**APPENDIX D**  
**Responses to HE comments**

## Lutterworth East Development

### Responses to Comments from Highways England – Dated 7<sup>th</sup> December 2016

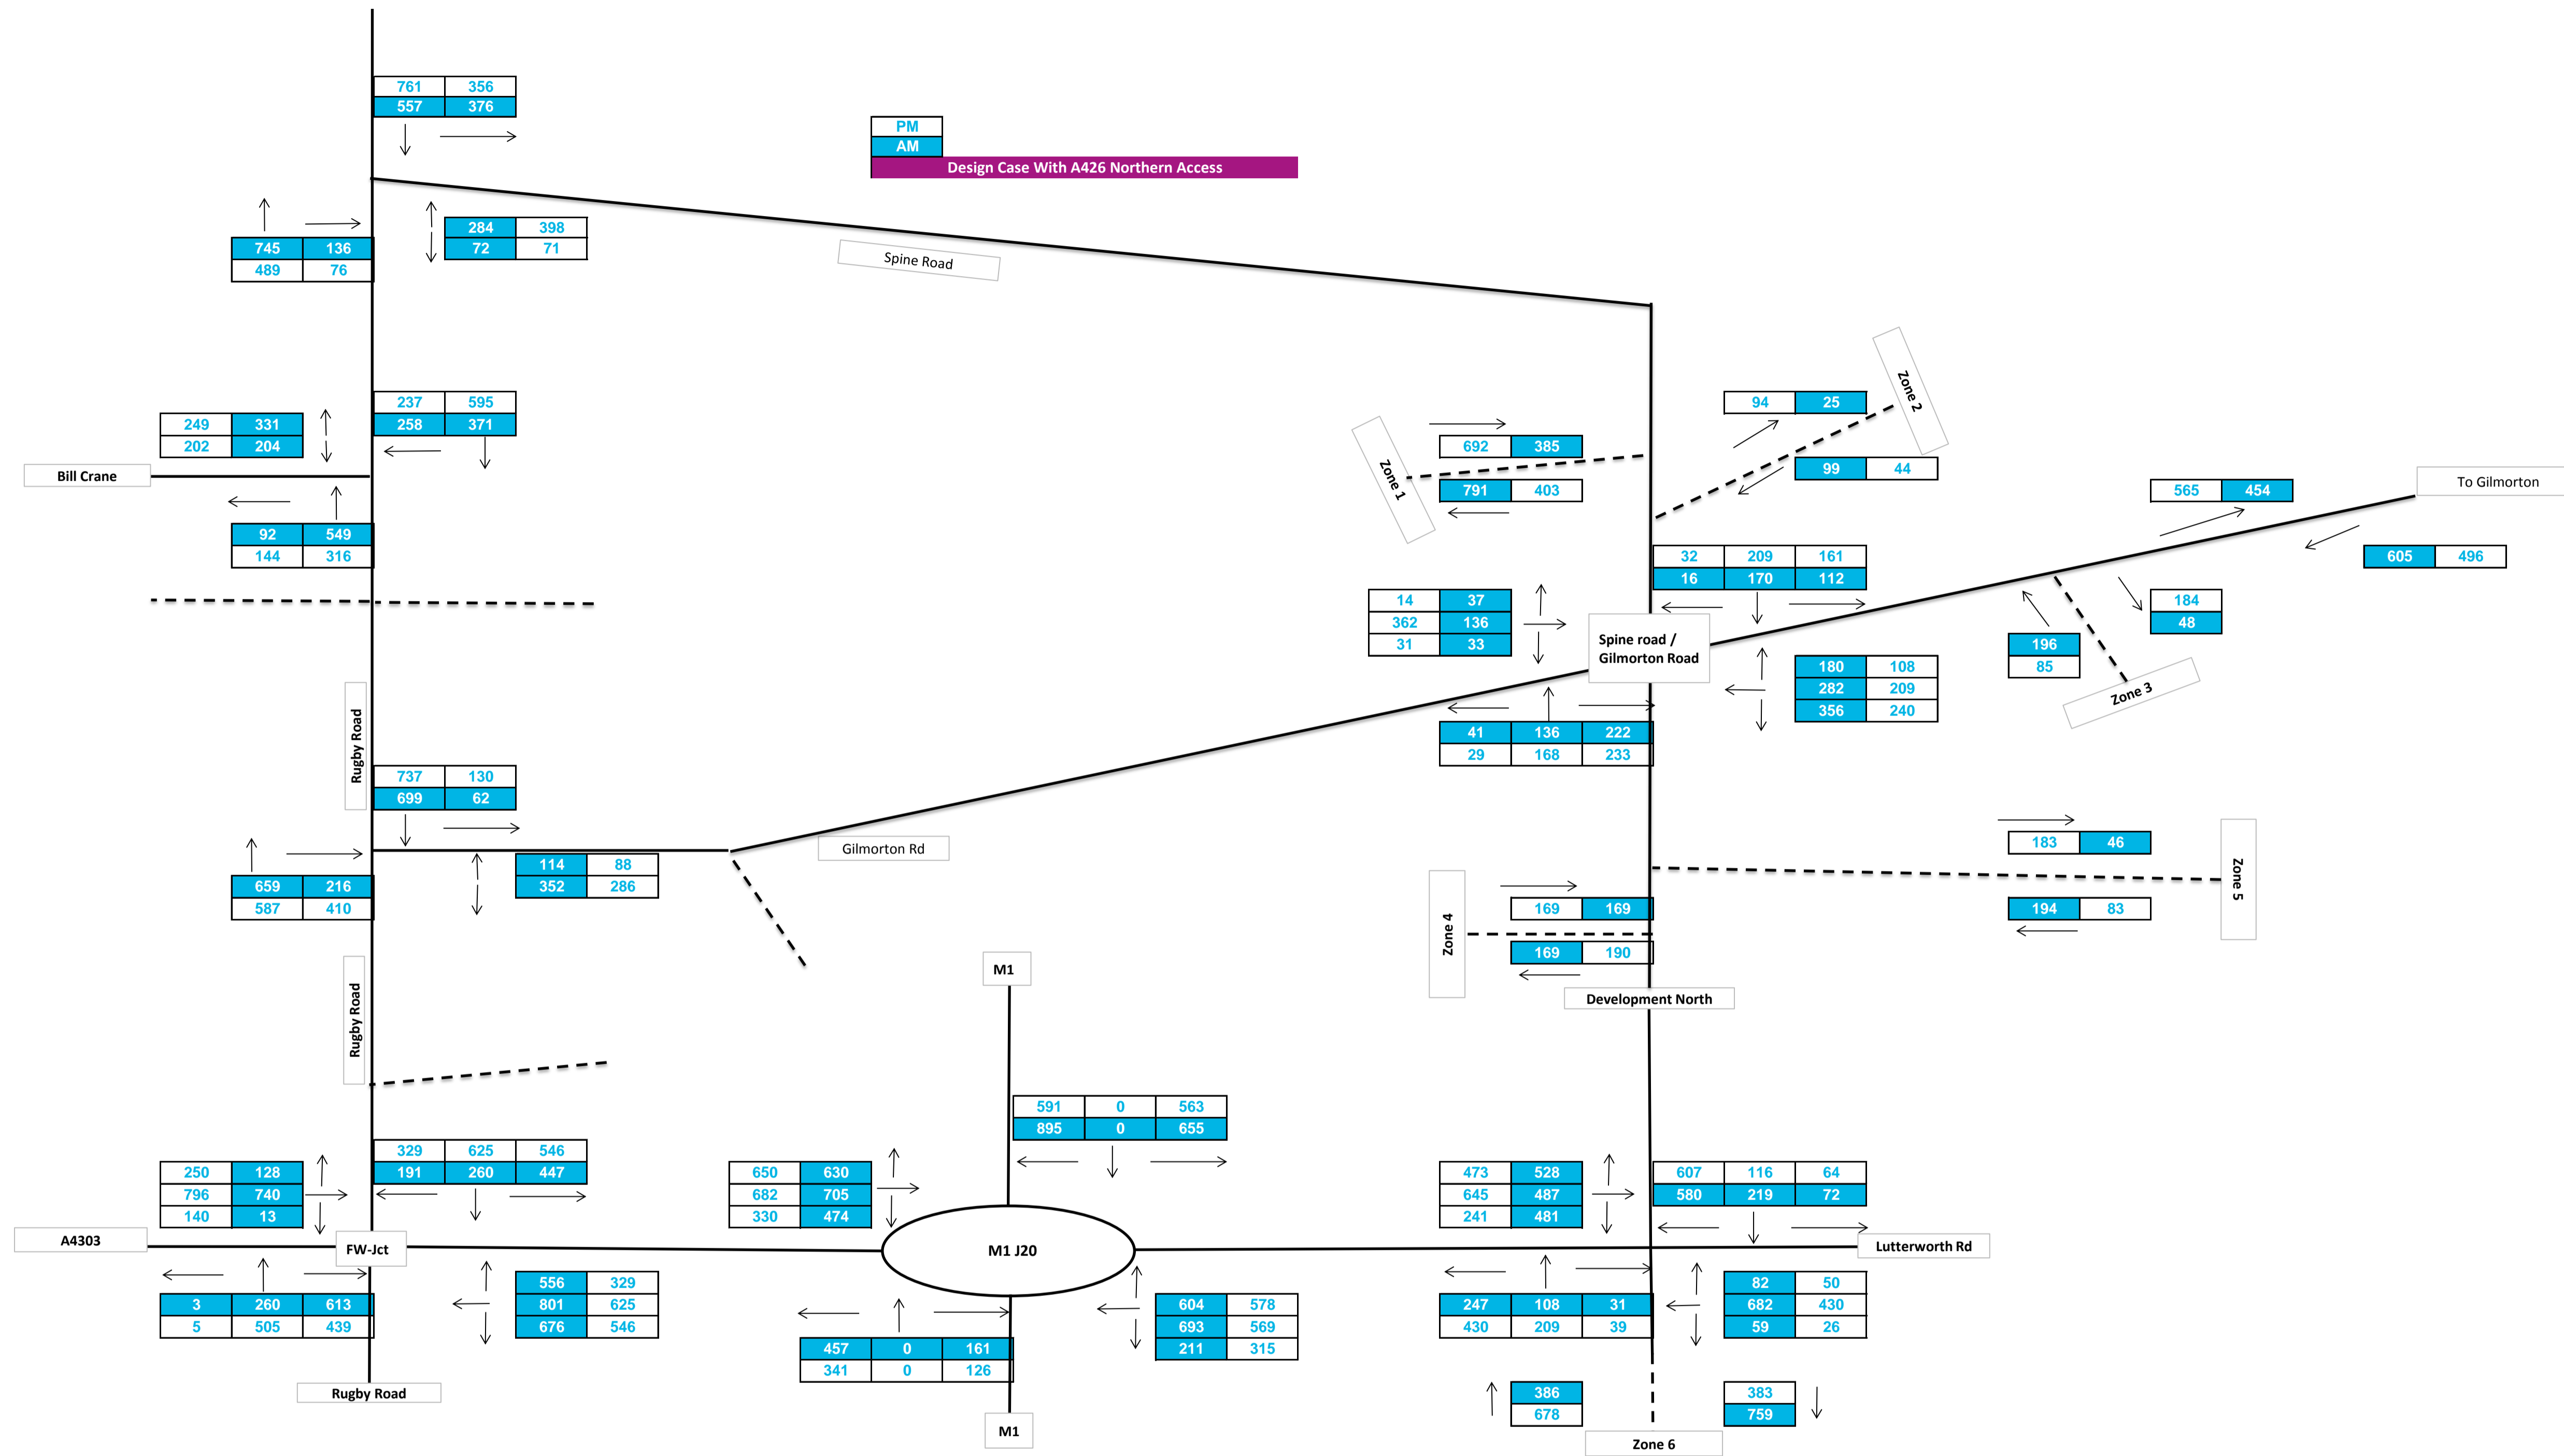
In order to achieve an agreement in principle for the development to be included within the Local Plan and secure that SRN continues to operate suitably, once all the outstanding issues have been addressed and the trip generation and assignment are agreed for each of the trigger points, we will be more than happy to check the VISSIM models for each assessment scenario.

Noted

The VISSIM model has not been updated with the latest changes. We suggest that this is undertaken once all outstanding planning and transport issues are agreed with HE and HDC.

Figure 1: Reducing residential trip rate as development size increases

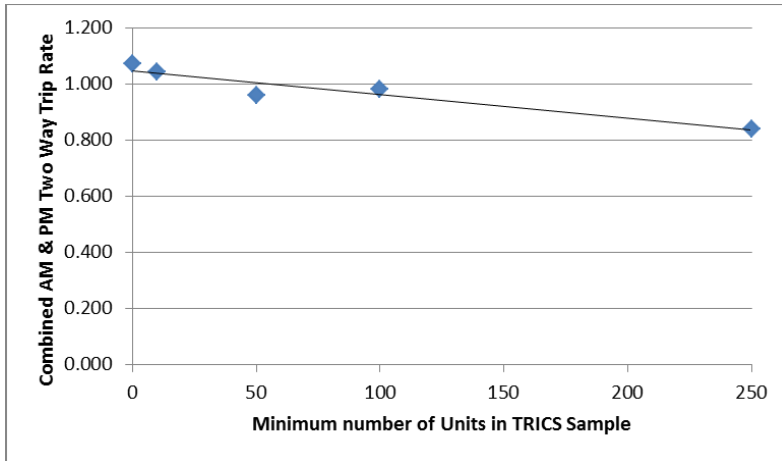
Both employment and residential trip patterns are lower in LLITM than average TRICS rates. However, further analysis of TRICS data (Figure 1) does indicate that, as residential size of development increases, so trip rates decrease.

Figure 1 shows that as the minimum number of dwellings in the TRICS sample is increased (i.e. selecting all sites with dwellings greater than X), the trip rate decreases. Unfortunately, the maximum number of dwellings contained within the TRICS sample is some way short of the 2,500 proposed here. Logically, however, a reducing trip rate with increased housing numbers makes sense: especially when considering that large developments would support their own employment, education and local shops. This is because the potential for internalised traffic is increased as development size (i.e. model zones) increases.

Figure 2: Reducing trip rate as development size increases

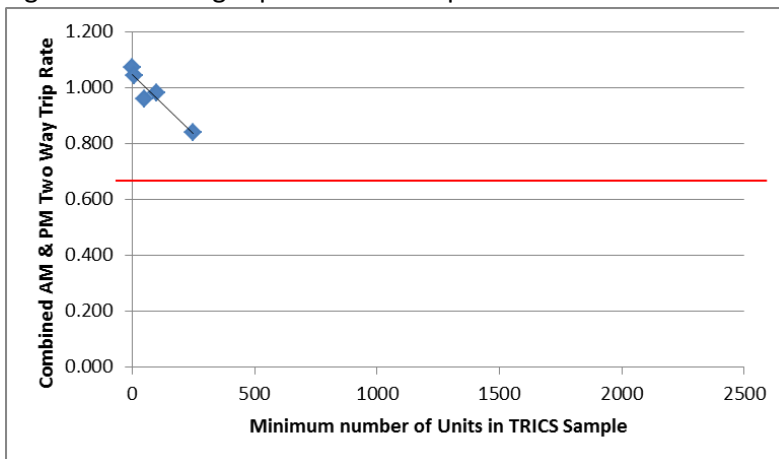
Figure 2 shows the data in Figure 1 with the 'x' axis extended to 2,500 dwellings and a red line added to show the combined AM and PM two-way trip rate from LLITM. *Clearly, the trip rate would need to level off at some point, and the relationship would not be linear.*
